WATER SERVICE PERMIT

RE: TB-18-326

Leroy St. (S.S.) 125' E. x Morton Ave.

BUILDING PERMIT PLAN (MAP 137, LOT 41)

BUILDING PERMIT PLAN
(MAP 137, LOT 41)

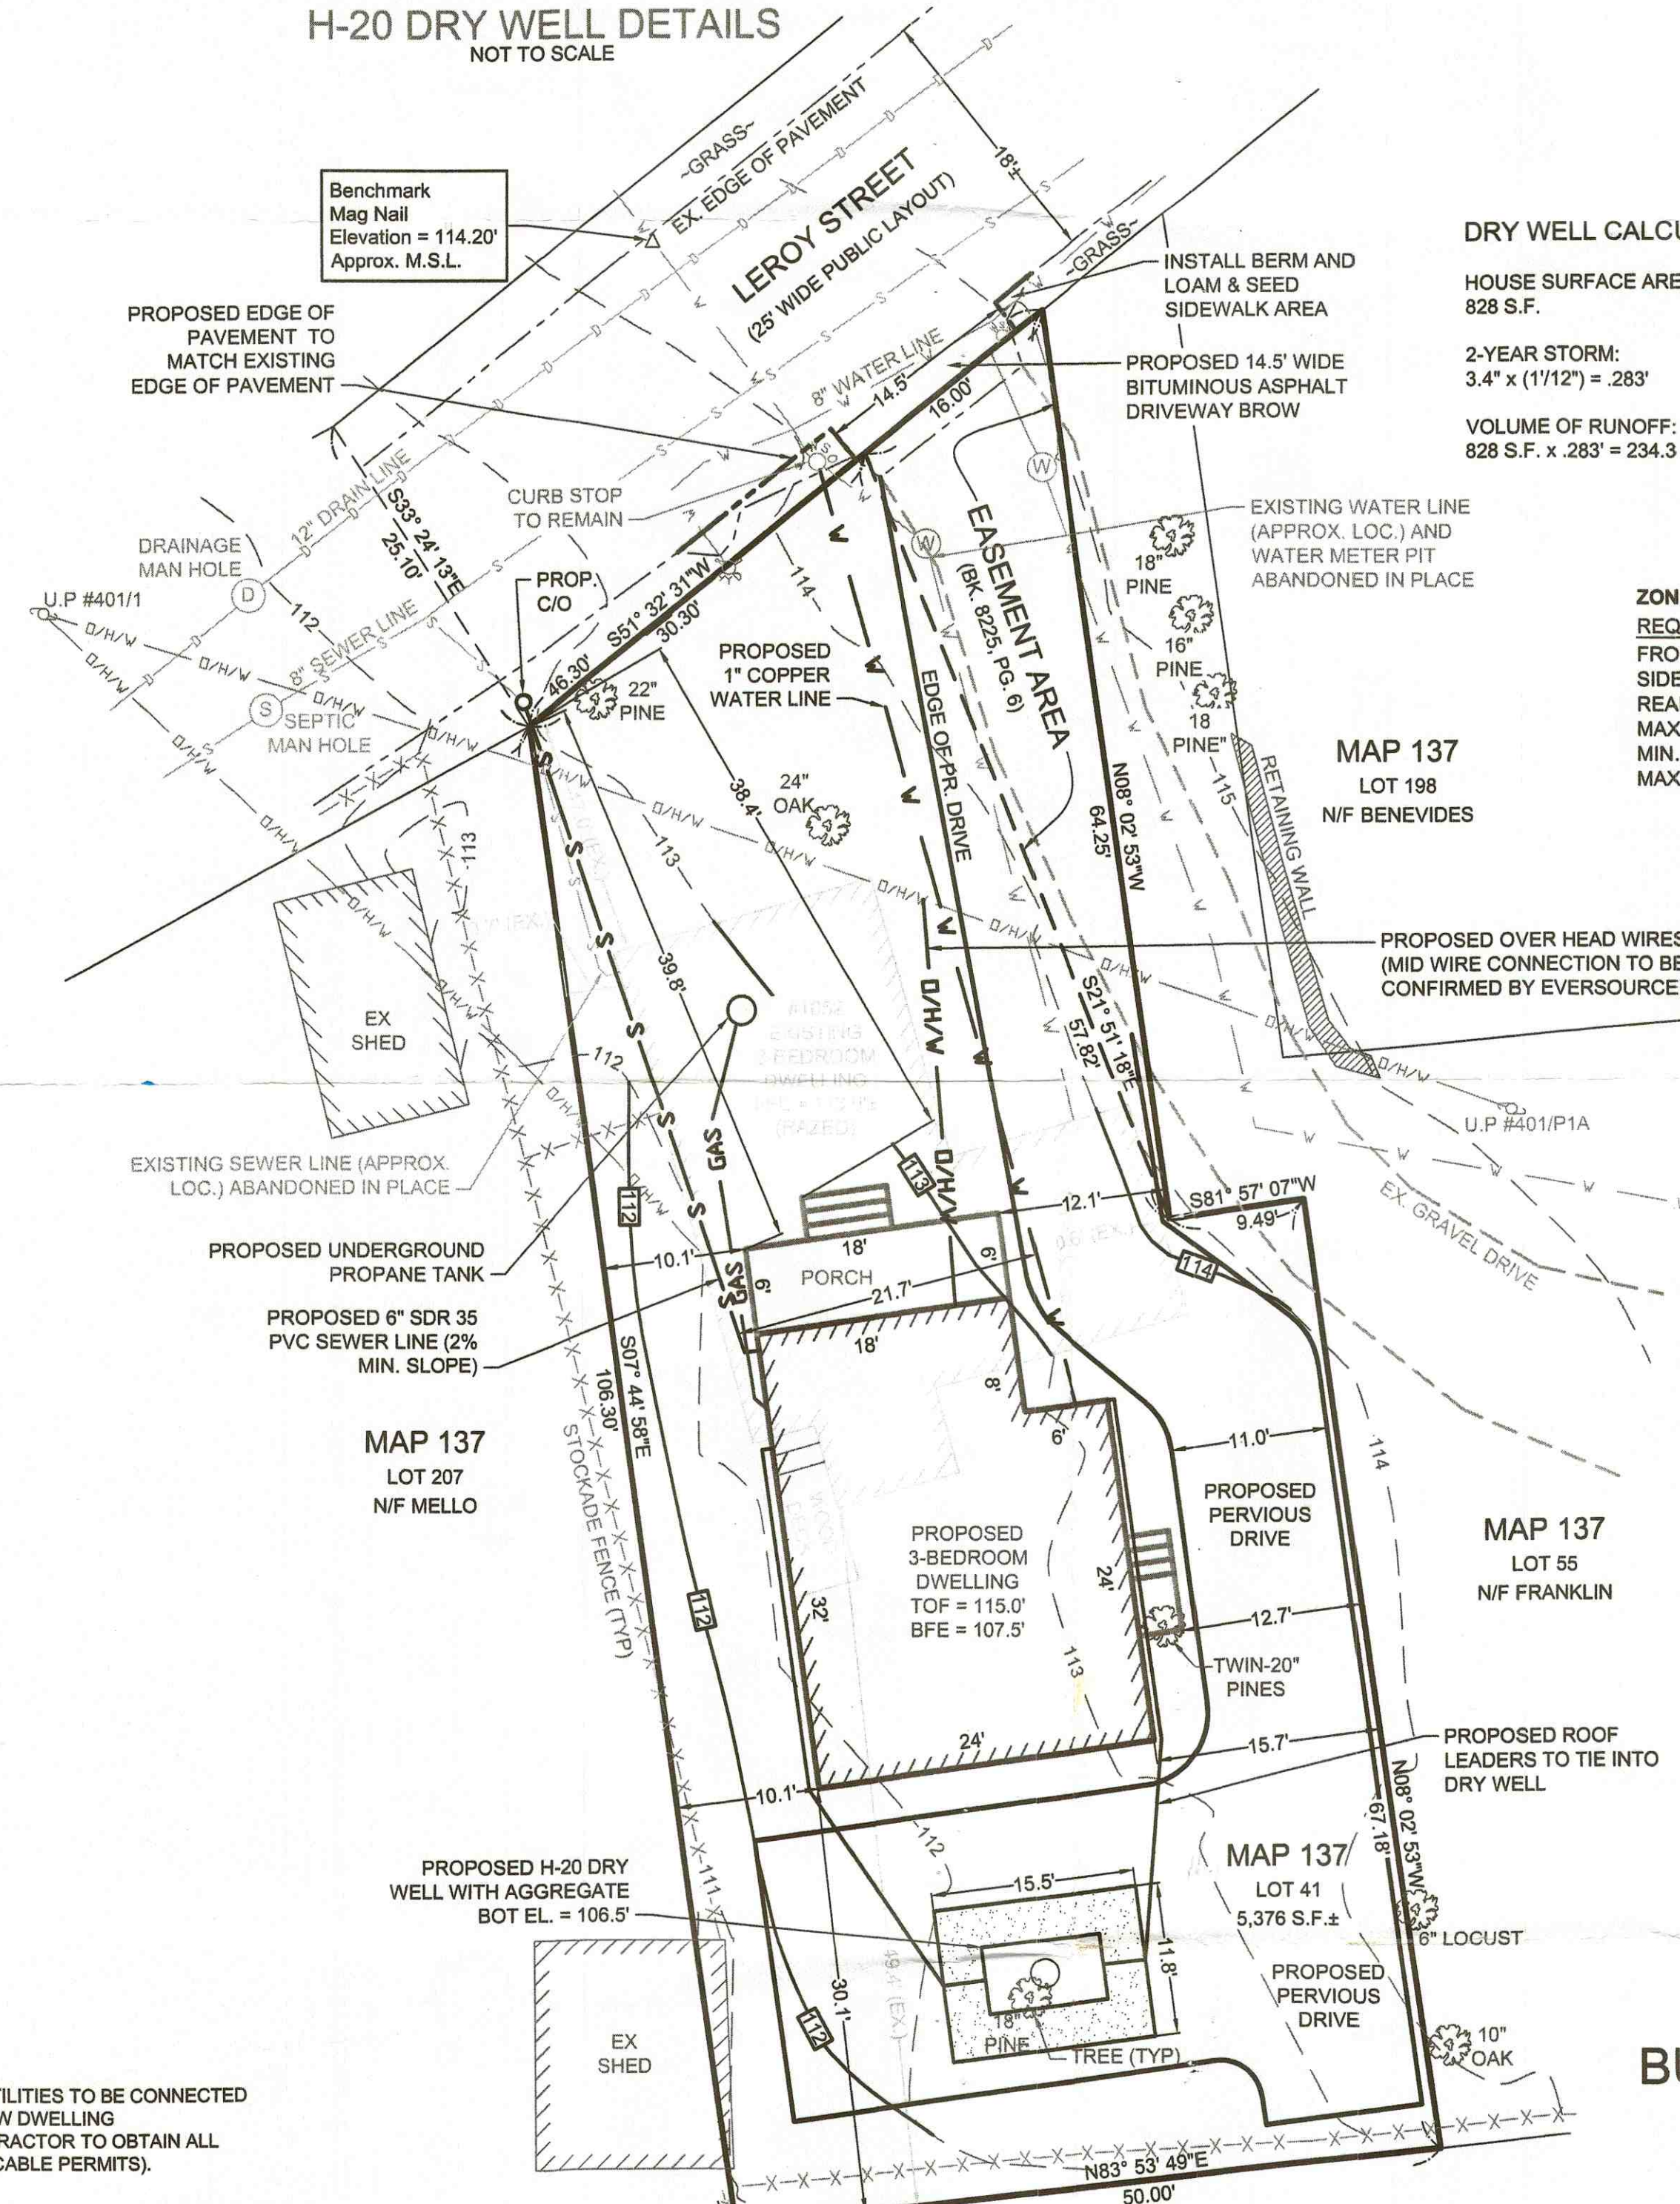
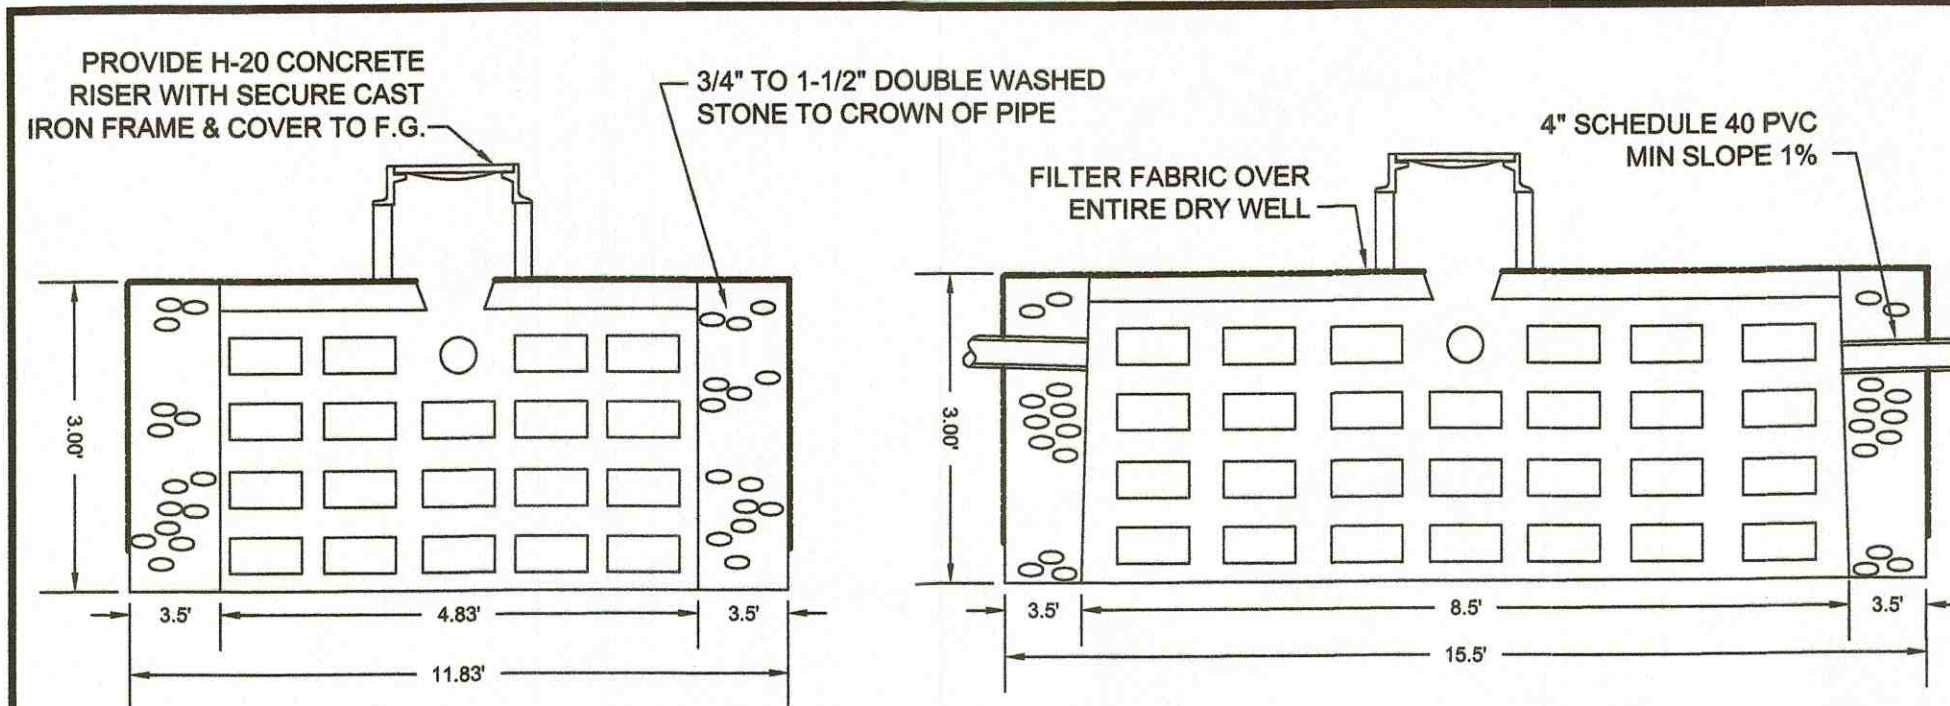
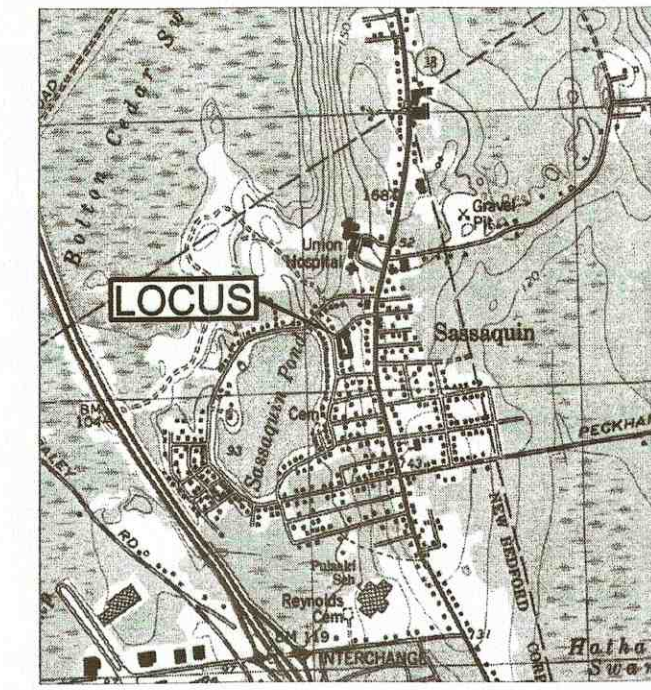
The site plan submitted via view permit for the above location does not contain sufficient information to conduct a proper review of the site and will need to be revised to meet D.P.I. requirements and construction specifications/standards. (Please Note: For this particular case, D.P.I. has marked up the submitted site plan with required revisions. Please visit D.P.I. to obtain a copy of the revisions and to review with a D.P.I. engineer. Moving forward, the following will apply for all subsequent site plan submittals prior to coming before D.P.I. for review.)

1. Please check that all existing site conditions are shown (i.e. utilities, mains/service connections, shut offs, clean outs, septic system (if any), driveways/sidewalks, curb/berm or edge of pavement, buildings, grading, etc.) and properly labeled.

2. Clearly depict and properly label all proposed work (i.e. new structure(s), water/sewer/storm drain mains/service connections or septic system, driveway(s)-new/closure/widening, storm recharge system for roof runoff/calculations/details, grading, etc.).

3. Check that the proposed building footprint on the site plan and the architectural drawing are the same since D.P.I. only approves the building footprint as shown on the site plan.

4. Check that the site plan being submitted has been stamped/signed by the proper professional(s) responsible for the site development and design (i.e. Professional Engineer and/or Land Surveyor, depending on the case).

1.) The site plan submitted via the View Permit system to D.P.I., titled: "Building Permit Plan, Map 137, Lot 41, for Leroy Street New Bedford, MA", having a revision date of 6/27/2018 (originally dated 3/19/2015), as prepared by JC Engineering, Inc. and stamped/signed by John L Churchill Jr., P.E. (Civil), was conditionally approved by D.P.I.

- : 1. Water service to be copper and 10ft away from sewer service.
2. Water curb stop/shut off to be 1.5ft from face of curb or pavement.
3. Water meter to be installed at the point entry 1.0ft inside cellar wall.
4. Owner to apply for a water permit.
5. All unused water services to be removed at the main.
6. Meter pit to be removed.
